In the Matter of:)
)
SIERRA CLUB, ENVIRONMENTAL)
LAW AND POLICY CENTER,)
PRAIRIE RIVERS NETWORK, and)
CITIZENS AGAINST RUINING THE)
ENVIRONMENT)
Complainants,) PCB 2013-015
v.) (Enforcement Water)
MIDWEST GENERATION, LLC,)
Respondent.)
)
)
)
)

Rebuttal Report to Expert Report of John Seymour, P.E.

James R. Kunkel, Ph.D., P.E.

December 8, 2015

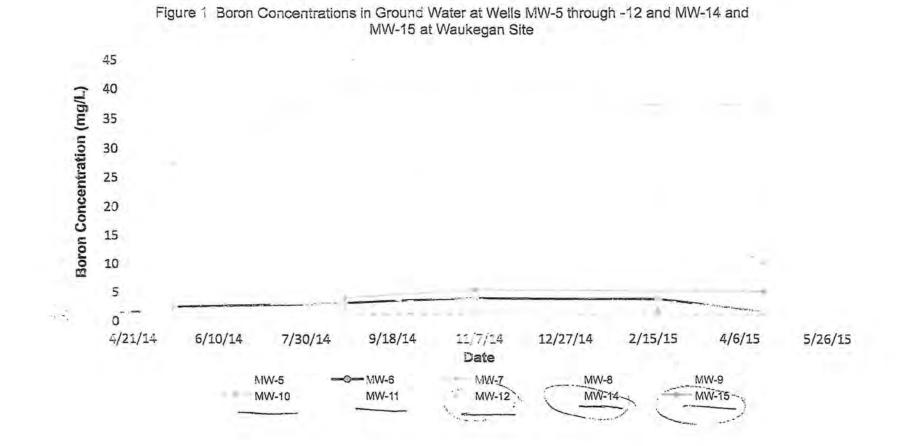
For example, Figure 1 shows recent MWG ground-water B concentration data for monitoring wells MW-5 through MW-15. Wells MW-10 through -14 (MW-13 is inactive) are ELUC wells which are up-gradient from the old coal ash storage area, and wells MW-5 through -9 and MW-15 are downgradient from the old coal ash storage area. Interpretation of the B concentrations on Figure 1 clearly show that the up-gradient wells (dashed

lines) have B concentrations much lower than the down-gradient wells (solid lines). ENSR (1998d) boreholes located near wells MW-10 through MW-14 (MW-13 is inactive) show that there is ash present in the soil which can account for the B and Mn concentrations at these monitoring wells, which were not part of the ash pond ground-water monitoring network.
